Swan_soundbar_sound_leackage Defect

ALT Co., Ltd.

Issued Date 2021.05.11

Ver.1.0

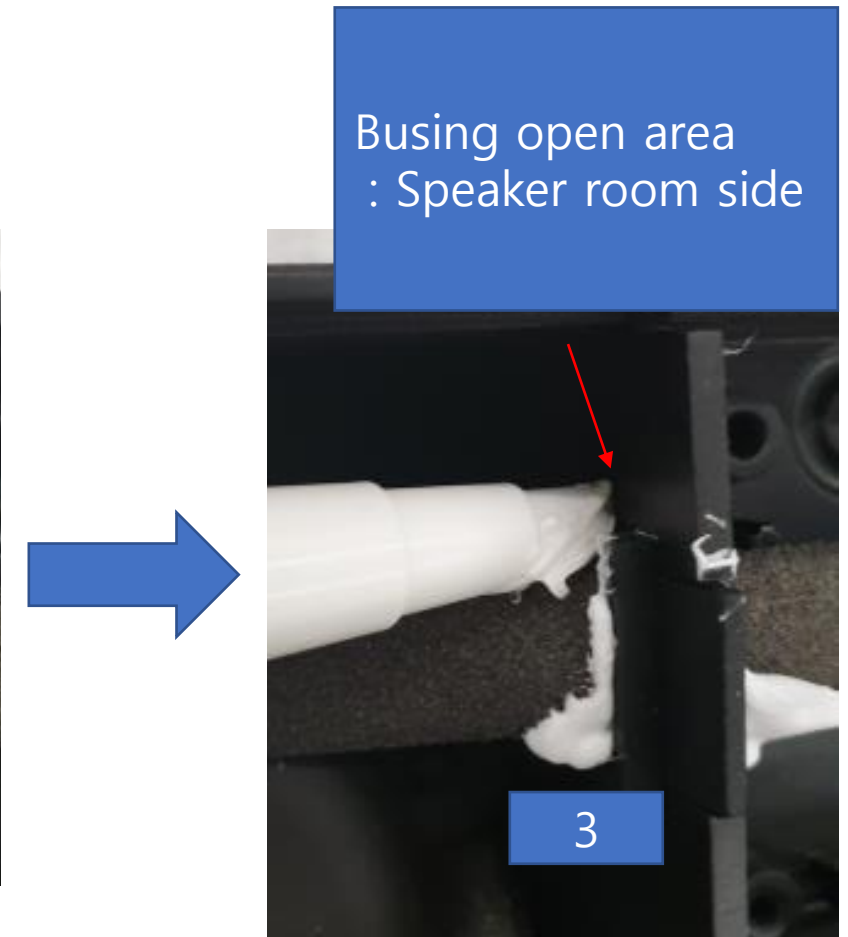
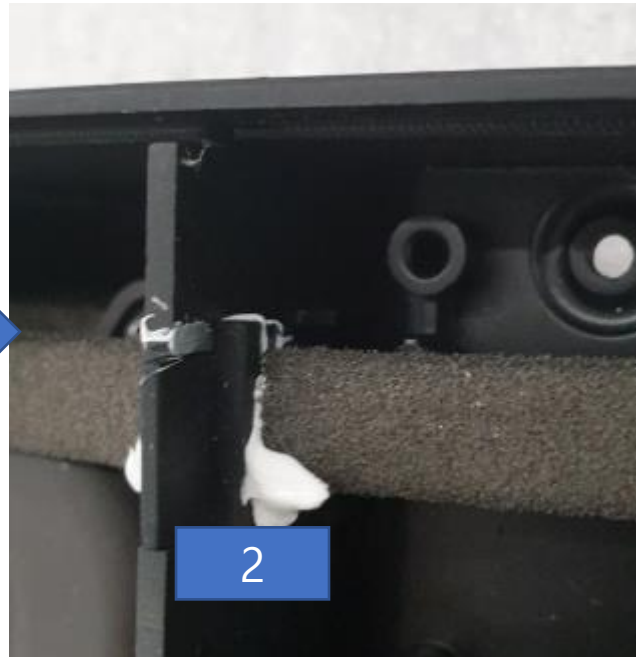
- Some of samples are leaking air due to DVT3 assembly quality
- FII has role of assemble according to the assembly guide, Check that assembly is correct.
- ALT is request air leakage test.
- Please make test solution and let's discuss

- Air leakage test guide
 - Play 50Hz sinewave. Max volume
 - Make reference sound recording file
 - Example sound :
https://drive.google.com/file/d/1uZLIY1OWCF6ecD1swkH5ToI_vh5IbW_5/view?usp=sharing
 - Make defect sound below case
 - Example sound :
<https://drive.google.com/file/d/1IlrkKzU8Su9SaS01Hc739a4pnBA55Jba/view?usp=sharing>
 - Top gasket assembly defect
 - Inner bushing defect : Assembly or material
 - Inner gasket assembly defect
 - Bottom screw missing
- Compare and validation between reference sound and mass production sound

- Recommend Glue apply method.

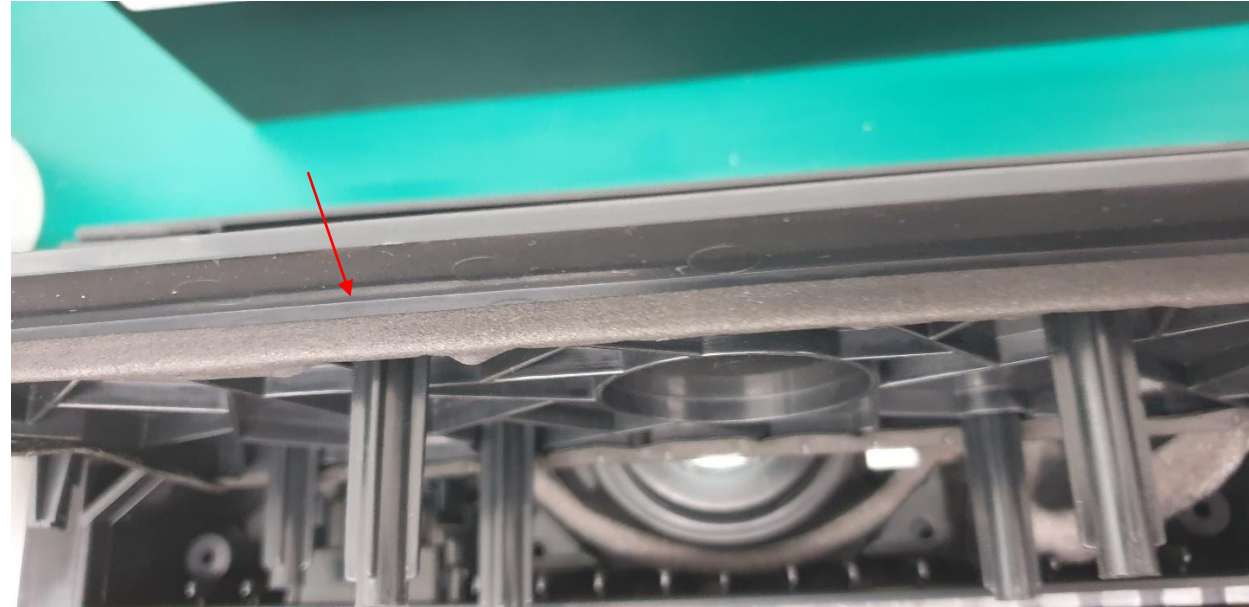
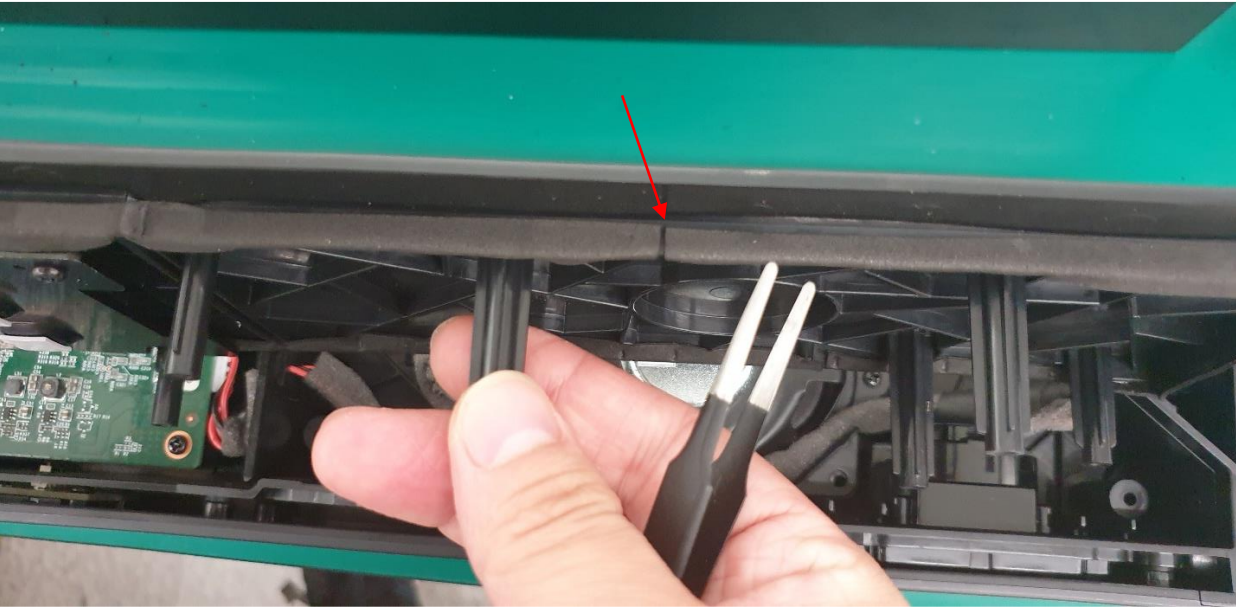
- Inner bushing glue apply defect

- Recommend Glue apply method.
 - Apply glue : DOWSIL_7091
 - How to apply glue
 1. Fill the inside on the bushing with glue
 2. Assembly with FFC cable
 3. Add the glue open area

- Gasket attachment defect

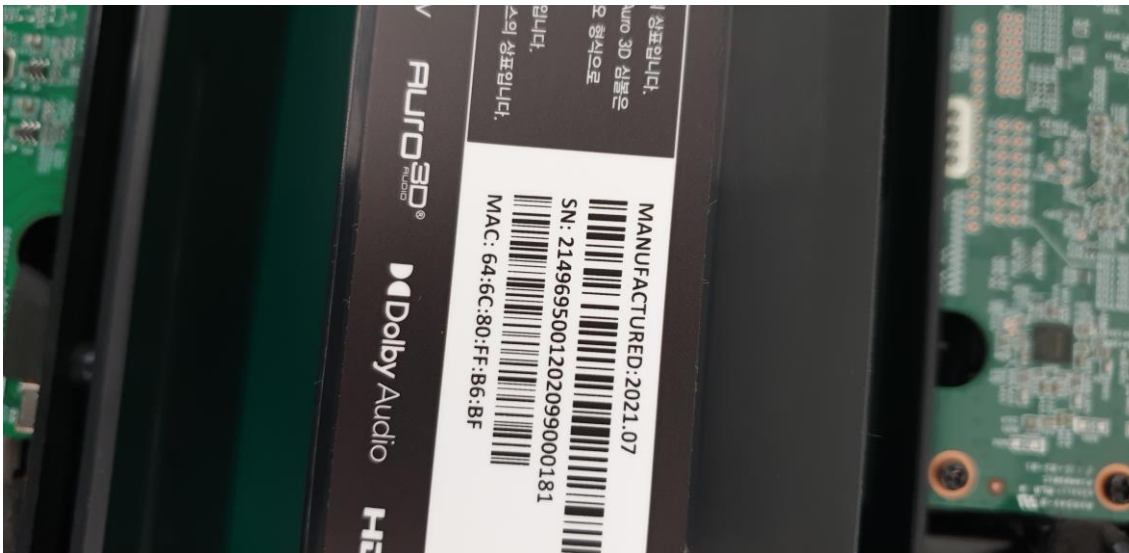
Gasket attachment line
The air leakage in this area
